**ATTACHMENT "B"**

**PSE's February 6, 2015, Comments in Docket No U-140621**

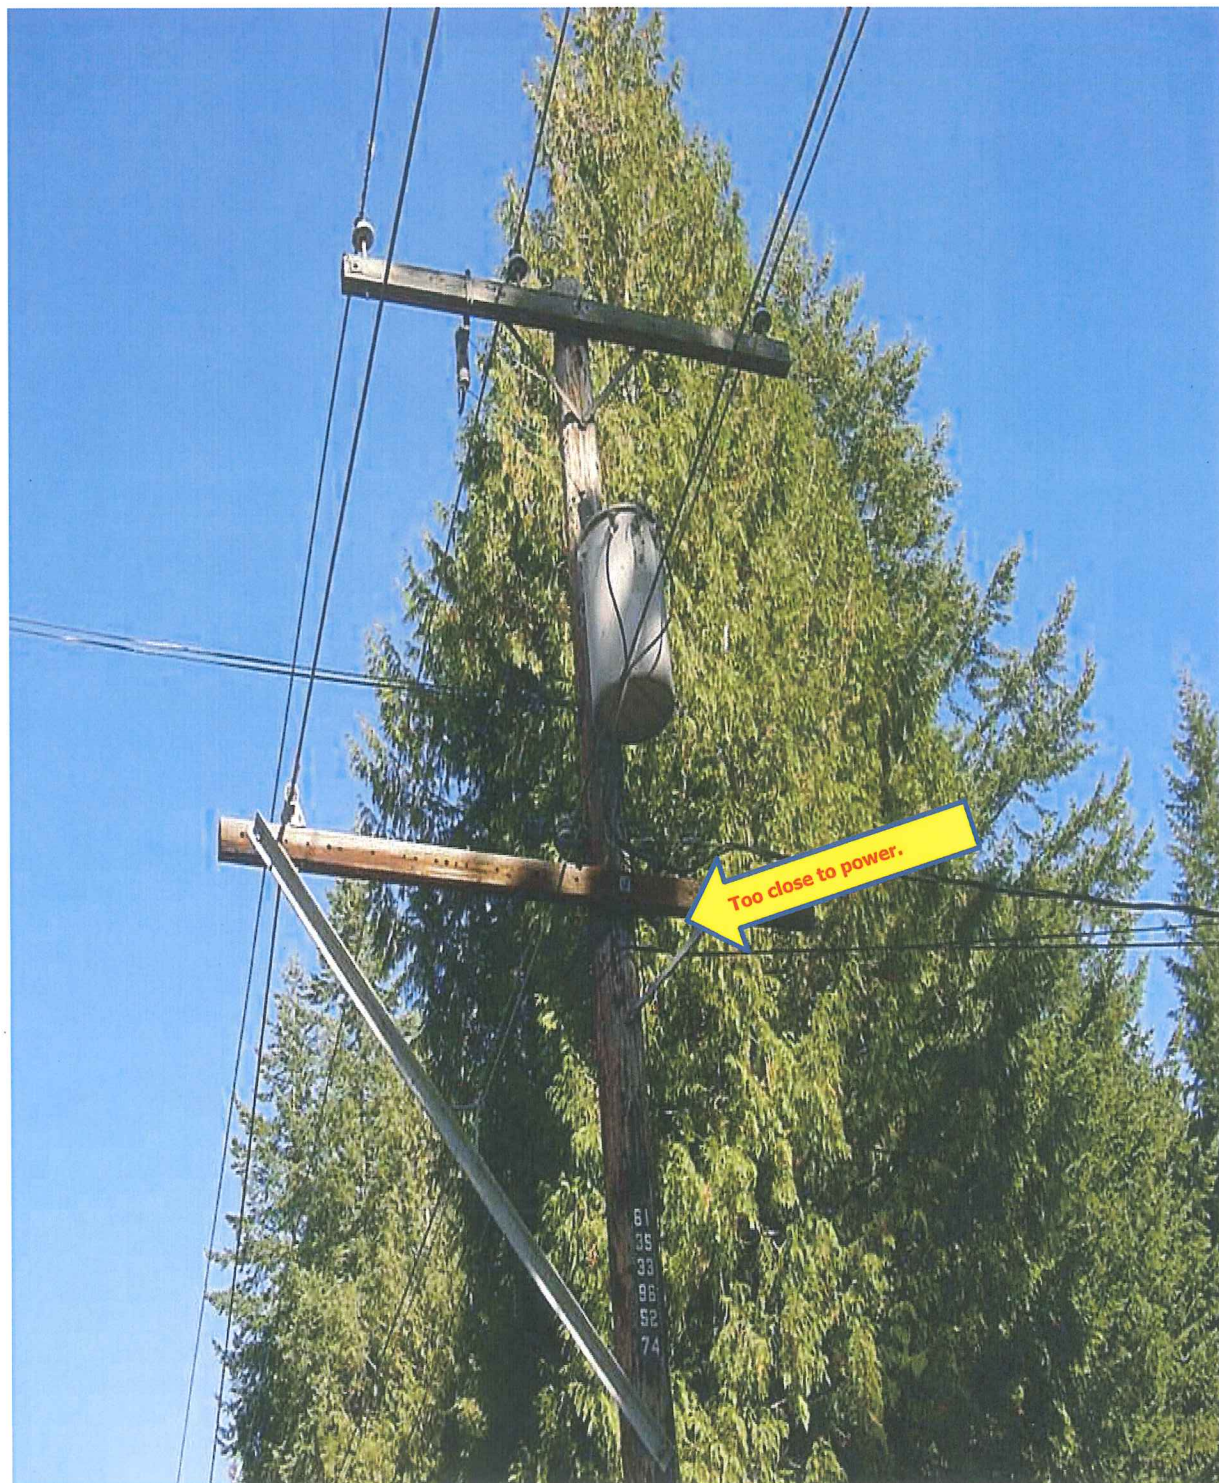
Both communications are too close to power. Lowest power is the bottom of the drip loop. Overlashing had occurred one week prior to this picture being taken.

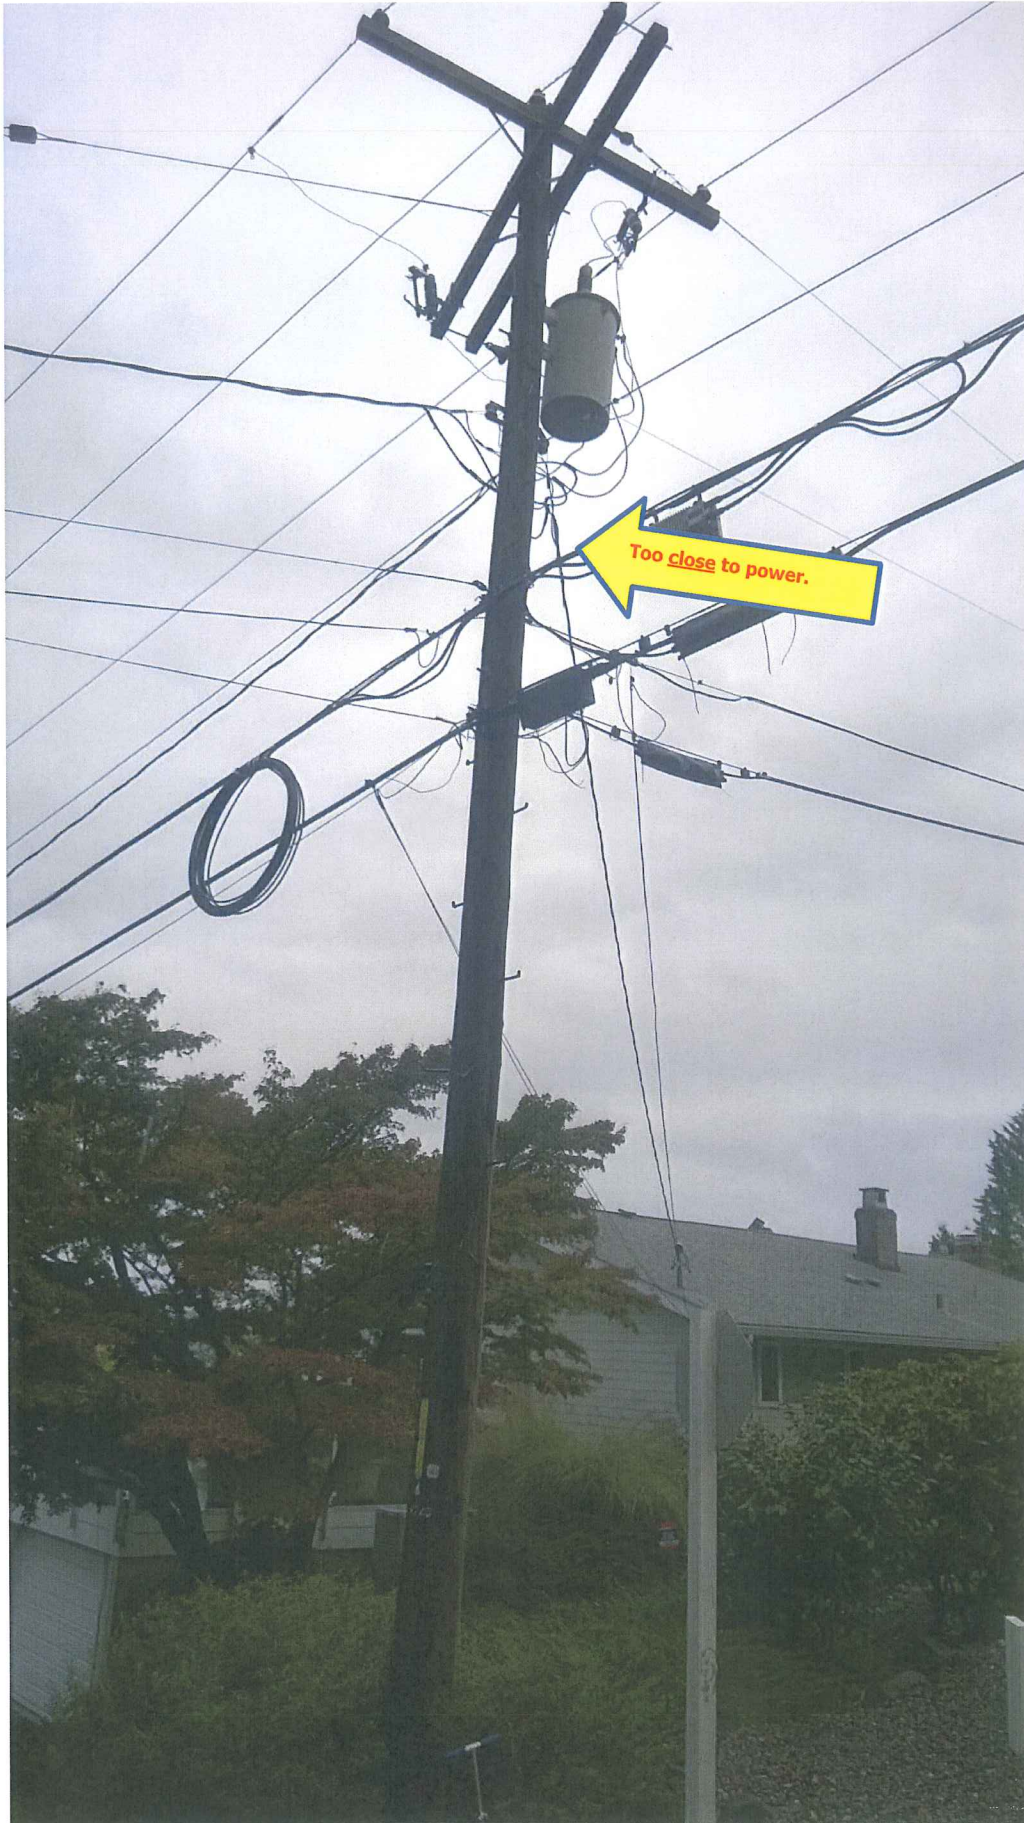
To close to power at mid-span. 30 inch minimum separation required.

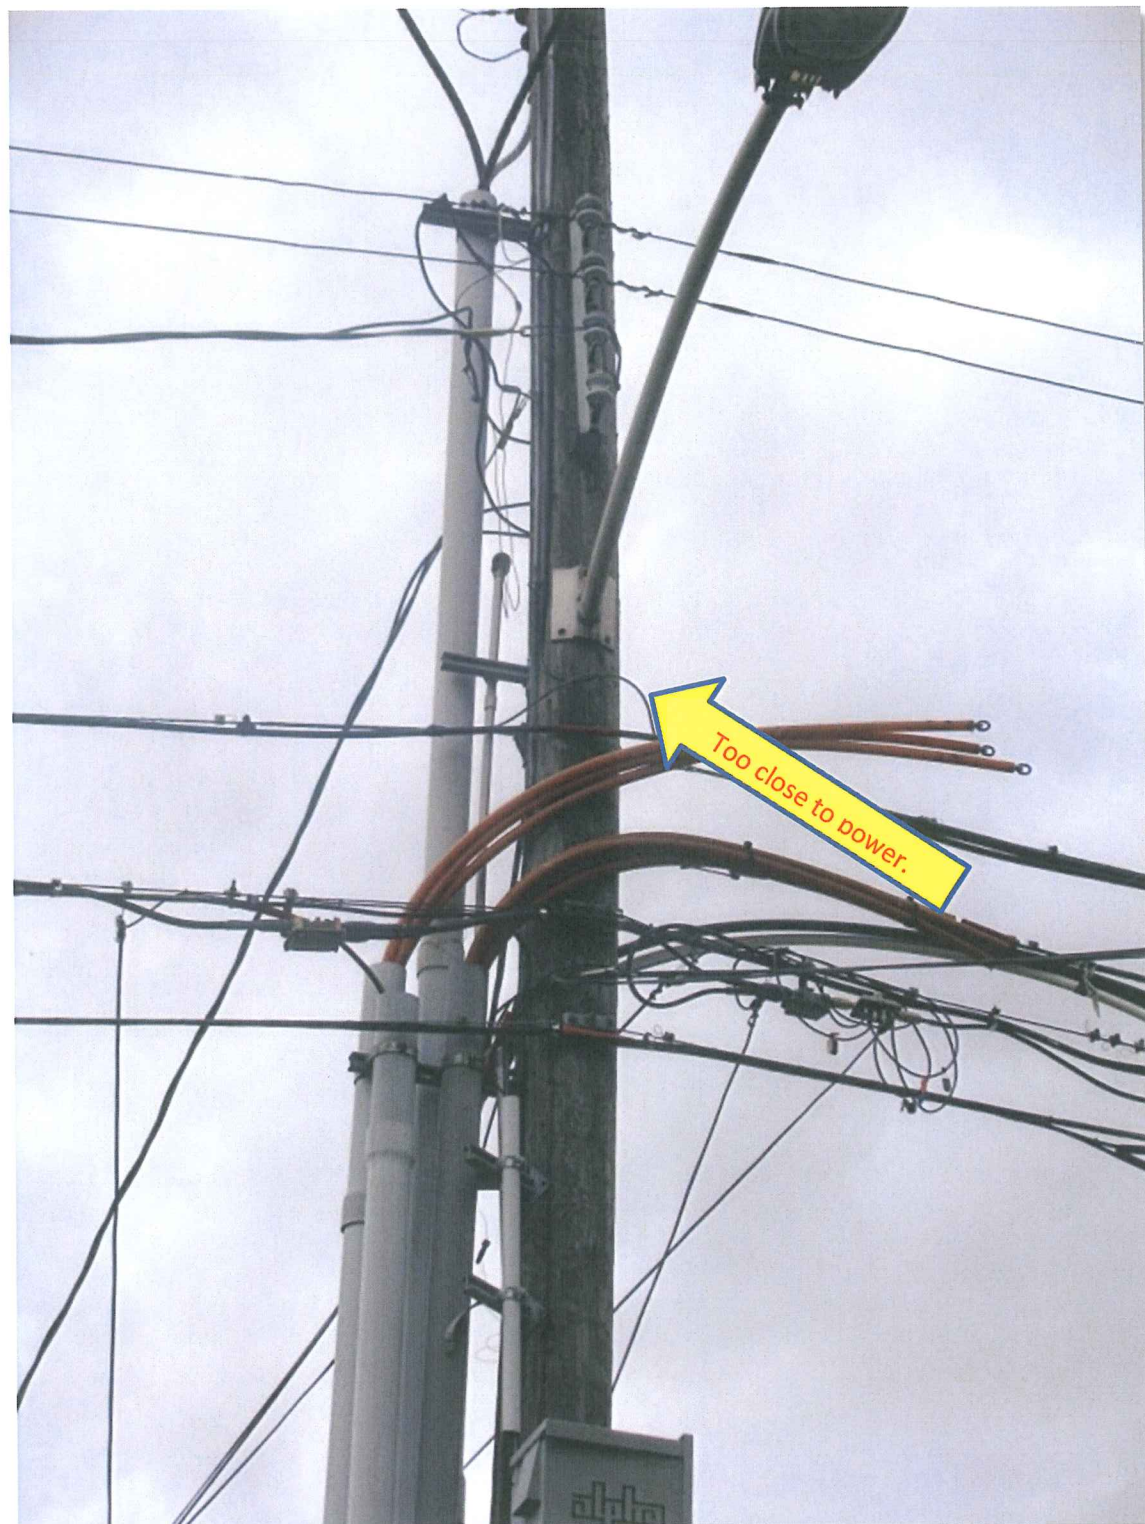
Too close to power. Incorrect build/install.

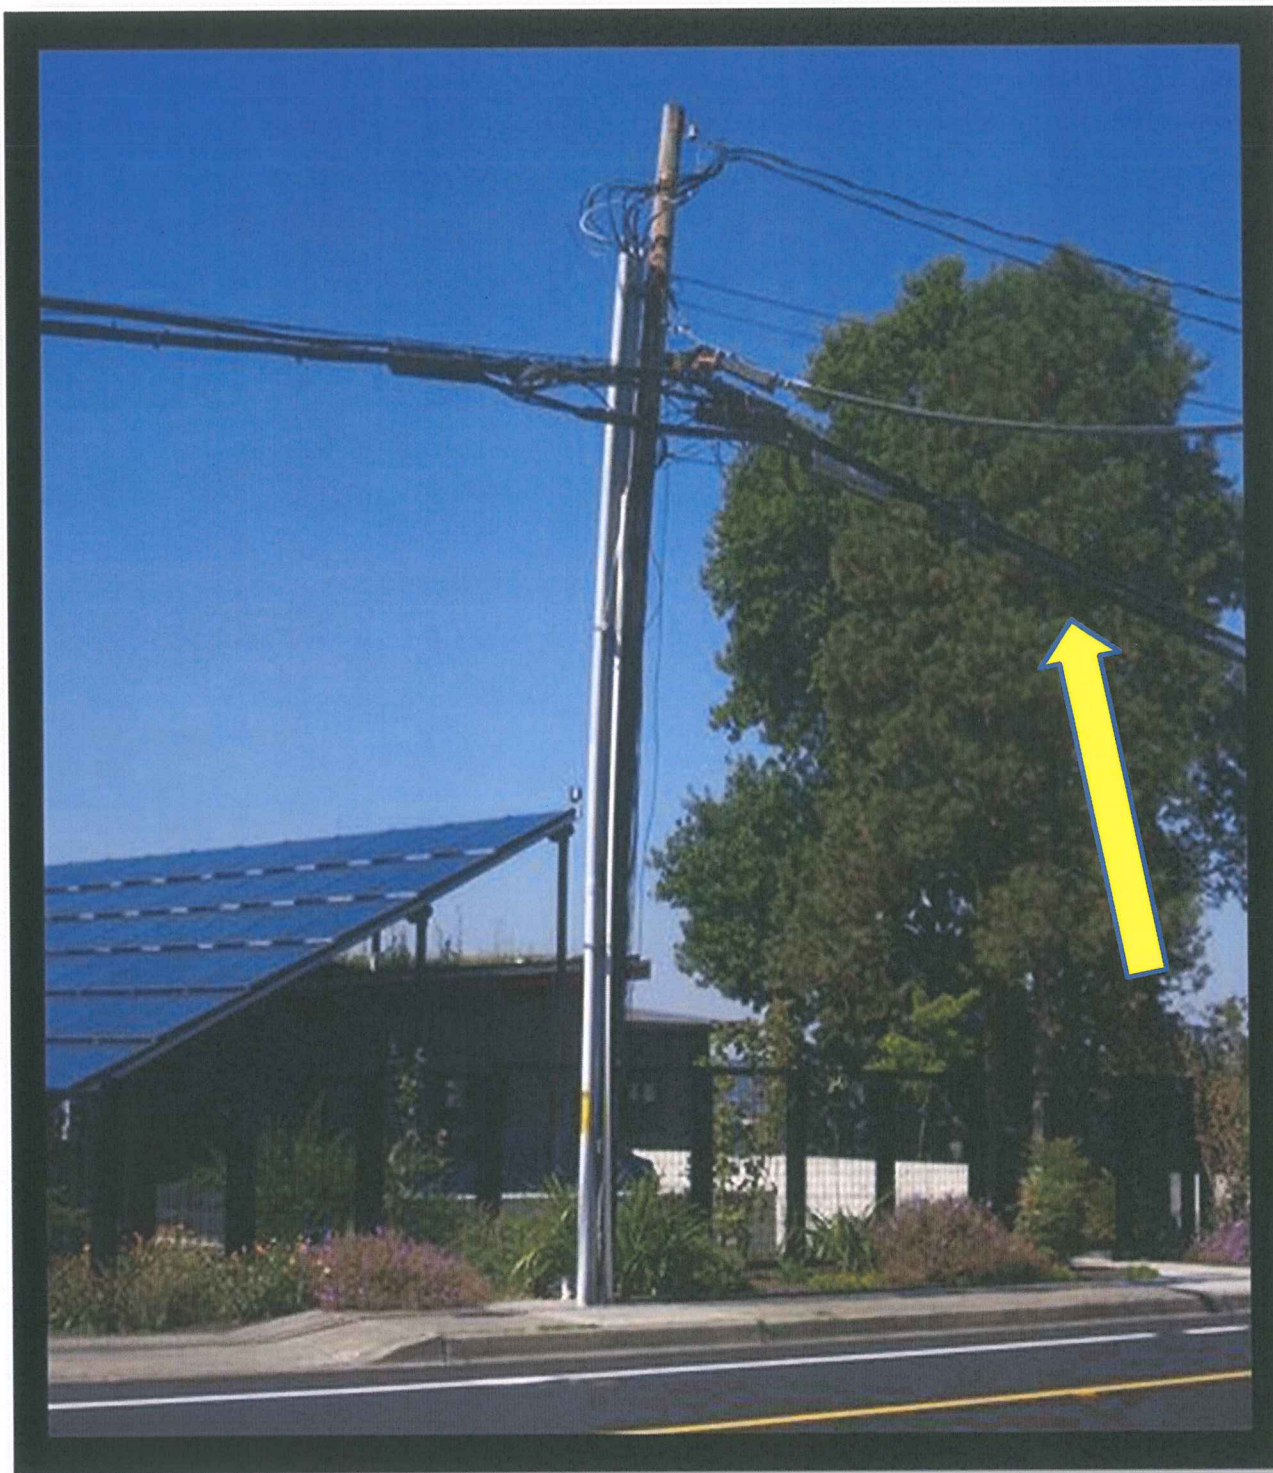
Note how overlashing can impact a pole.

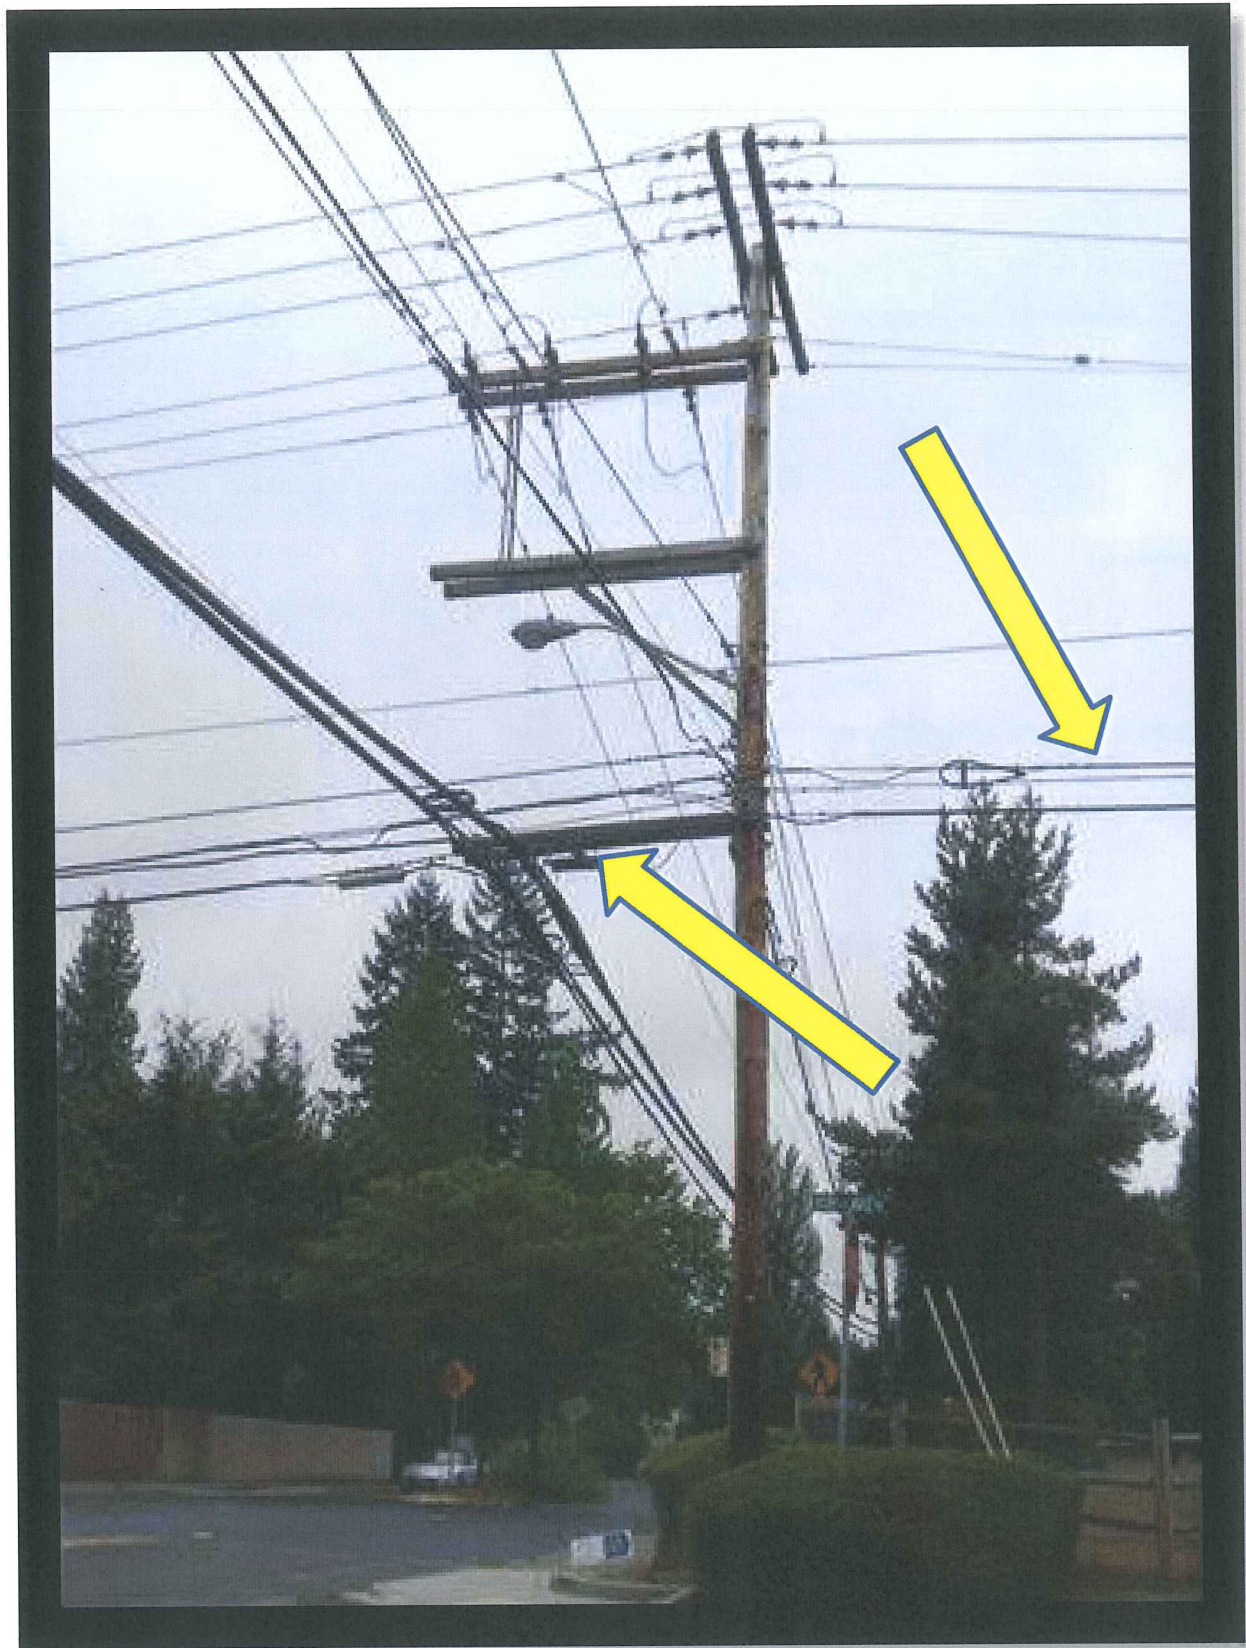
Note size of conductor bundles that are overlashed.

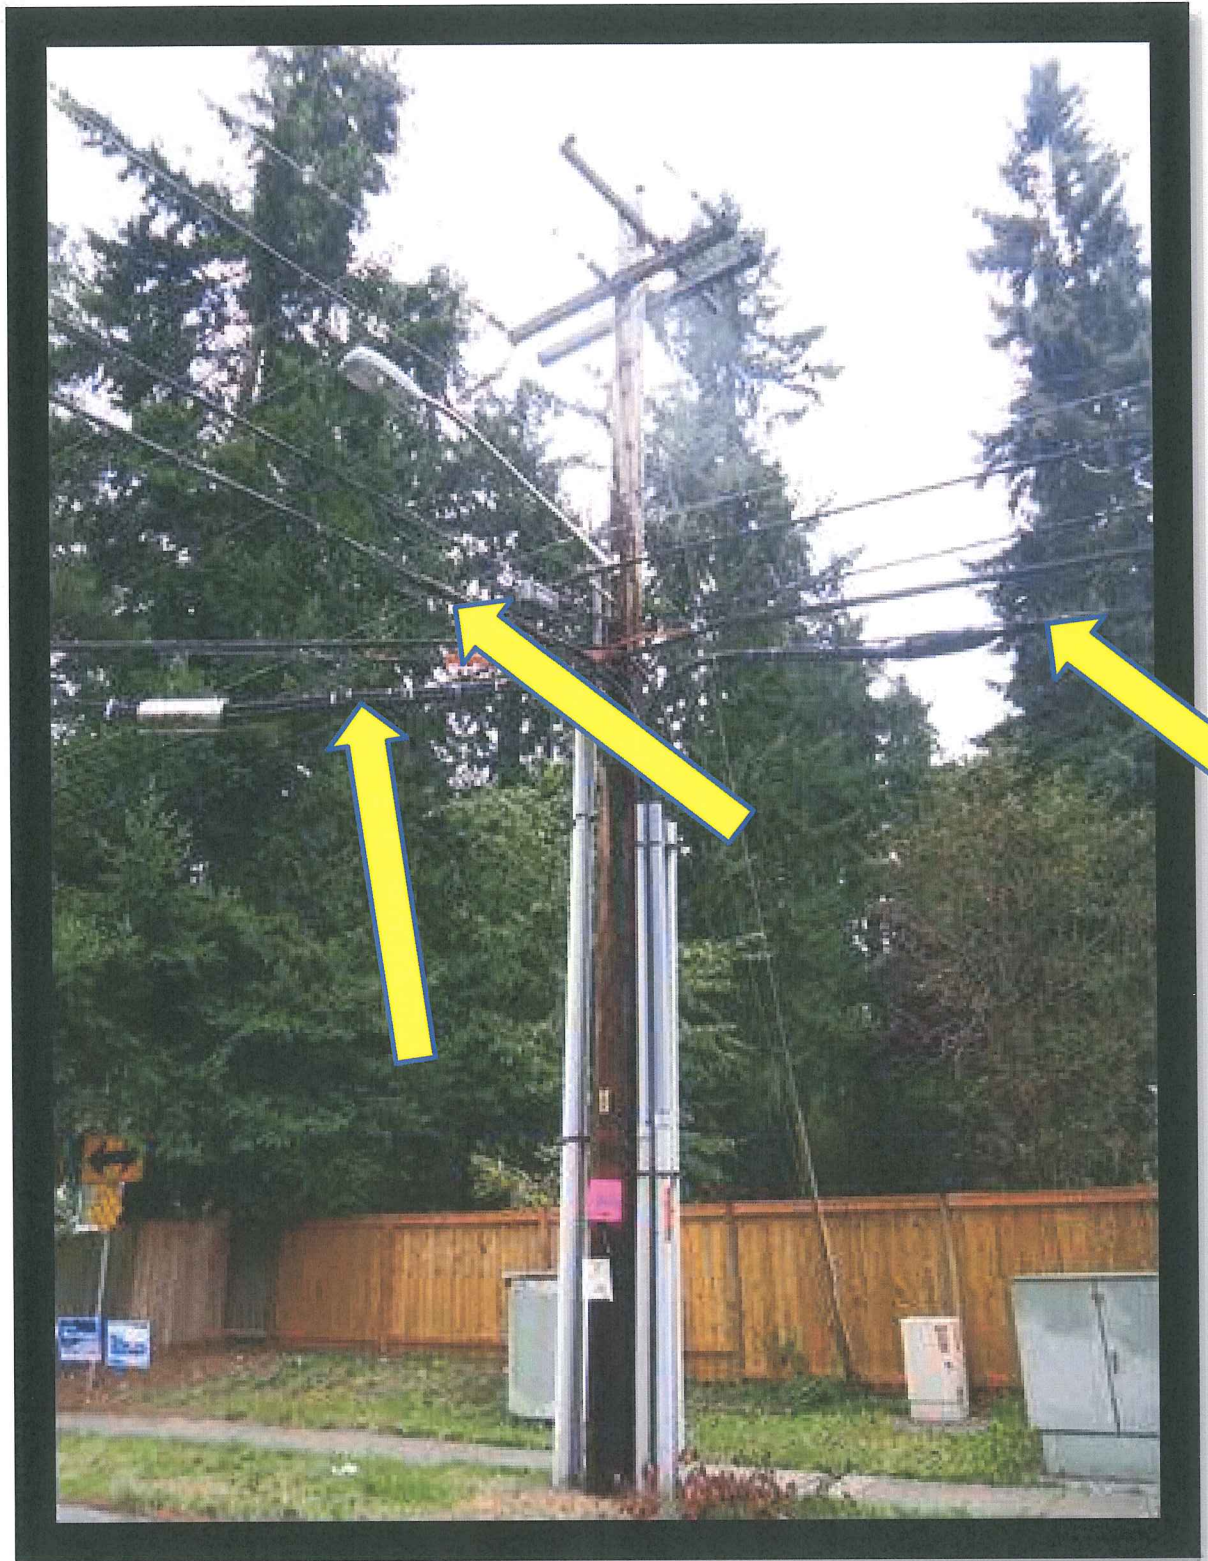
Note amount of overlashing and size of overlashed conductor bundles and installation of stand-off bracket. Also, note the impact on the pole.

Note amount of overlapping and size of bundles.
